610.15360 Odour Letter 20151027.docx

**Sydney 1 Project
One Alfred Street
Odour Issues**

SLR Consulting Australia Pty Ltd (SLR) has been engaged by Kerry Hill Architects Pty Ltd to provide a response to submissions relating to odour impacts upon the Sydney One Project (SSD 2015_7101) and amending Development Application (DA 3015_882).

Figure 1 Levels 3 – 5, Sydney 1 Project

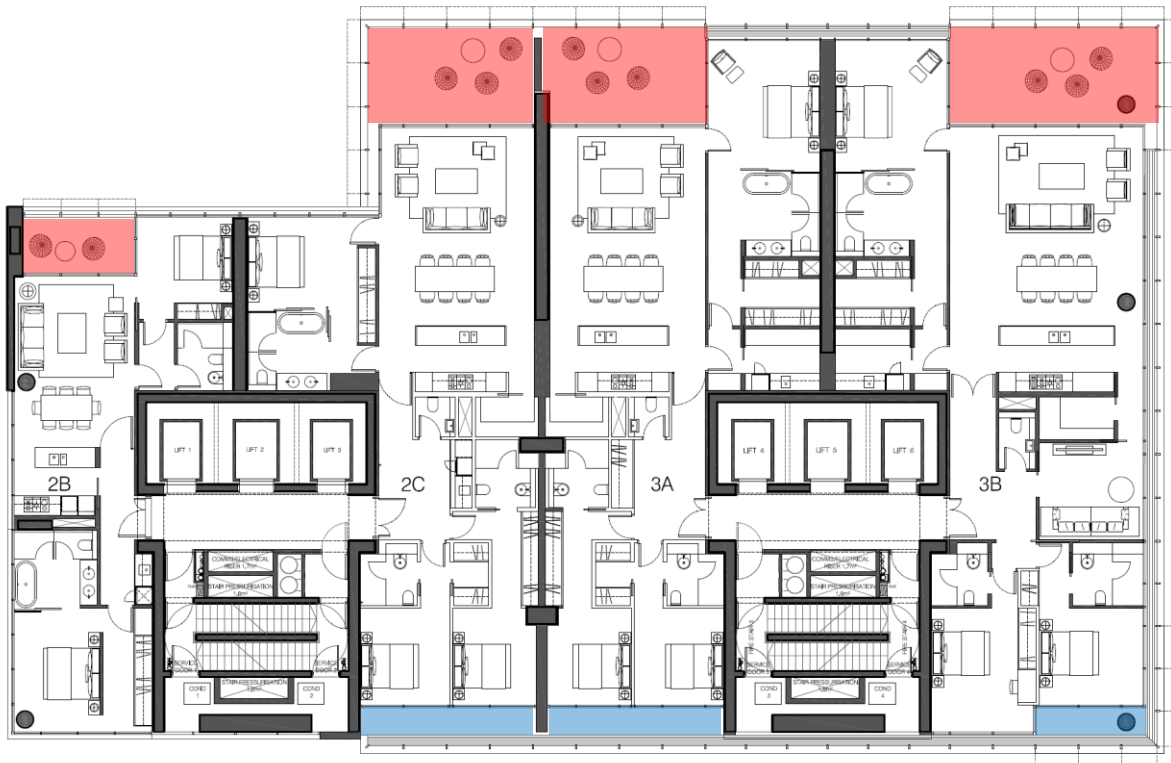
The design of levels 3 to 5 and 7 to 35 of Tower A of the Sydney 1 Project is presented in **Figure 1** and **Figure 2**, respectively. Proposed primary balcony areas ('Winter gardens') are shown in red in **Figure 1** and **Figure 2** which are generally large (approximately 3.5 m wide) and located on the northern façade or corner of the tower. Many of these balconies will command views of the harbour foreshore and a number of Sydney landmarks, hence the description as the primary balcony for each apartment.

On levels 3 to 5 and 7 to 35 of Tower A, three secondary balconies are also proposed on the southern façade as denoted in blue in **Figure 1** and **Figure 2**. These secondary balconies are small (1 m in width) and are accessible only from the bedroom areas. As such, the use of the secondary balconies is likely to be infrequent and of shorter duration than for the Winter gardens.

Notwithstanding that the potential level of odour impact upon Tower A is not clearly defined, SLR understands that all balcony areas on the southern façade of Tower A are openable, but will be fitted with an air seal to prevent any odours from entering the apartment when balcony doors are closed. As these are the secondary balconies for the residential units, the use of these would be limited, and may be closed to prevent the ingress of odour if required.
